Reference: U.S. Geological Survey TRIGA Reactor (GSTR), Docket 50-274, License R-113
Request for Additional Information (RAI) dated September 29, 2010

Subject: Response to Questions 17.1 and 17.2 of the Referenced RAI

Response to request for additional information questions numbered 17.1 and 17.2.

Figure 17.1 Top and side views of the model for calculating the scattered dose in the SE corner after a LOCA

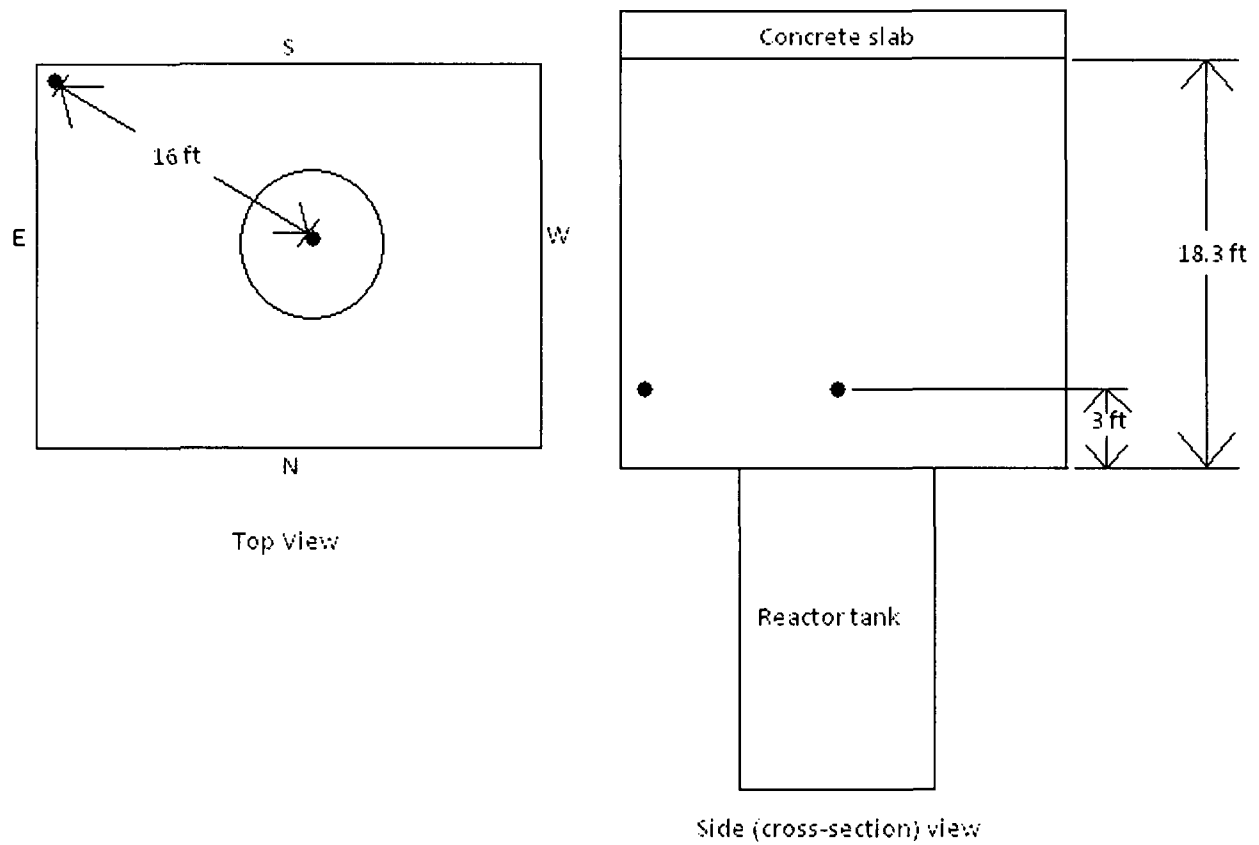
The Geological Survey TRIGA Reactor (GSTR) Safety Analysis Report (SAR) section 13.2.3.2.2.3 calculates the dose rate at 3 feet above the reactor tank cover grating, after a loss of coolant accident (LOCA) from direct radiation from the core. Section 13.2.3.2.2.4 calculates the dose to a person standing in the reactor room after a LOCA from scattered radiation and not from direct radiation from the core. Section 13.2.3.2.2.5 calculates the dose to a person standing at the east fence of the Denver Federal Center (DFC) during a LOCA from scattered radiation and not from direct radiation from the core. All the dose calculations after a LOCA in the SAR are incorrect and need to be updated. The basic assumption for the calculations is that the reactor has been operating at a maximum power level of 1 MW for one continuous year, and then the cooling water is instantly lost. This is a very conservative assumption, since there is no conceivable way the GSTR could be operated continuously, 24 hours per day, at 1 MW for one year, nor is there any way all of the cooling water could be instantly lost. The GSTR normally operates on a 10-hour-per-day shift for 5 days per week.

The second point of interest for calculating the effective dose equivalent rate is located in the SE corner of the reactor bay, 3 ft above the floor, and 16 ft away from the vertical line intersecting the center of the core. This point is the furthest distance a person can get from the edge of the reactor and remain in the reactor bay. The ceiling immediately over the reactor tank is a staggered ceiling with a steel access hatch and concrete support. To yield a conservative dose calculation it will be modeled as a concrete slab located 18.3 ft above the floor of the reactor bay. In reality the scattering will not be as great as calculated because the radiation from the unshielded core will undergo less interaction with the roof. A representation of this model is shown in Figure 17.1.

Using equations (1) through (6) the flux of gamma rays incident upon the SE corner dose point can be calculated. Then as before, the ICRP 51, Table 2 dose factors were used to calculate the effective dose equivalent at that position. The anteroposterior geometry was used as it gave the largest dose factor for 0.232-MeV scattered photons, of $1.20 \times 10^{-12} \text{ Sv cm}^2$. Unit conversion factors of 100 Rem/Sv and 3600 s/hr were also applied. The flux and effective dose equivalent for the SE corner position from Figure 17.1 are shown in Table 17.2.
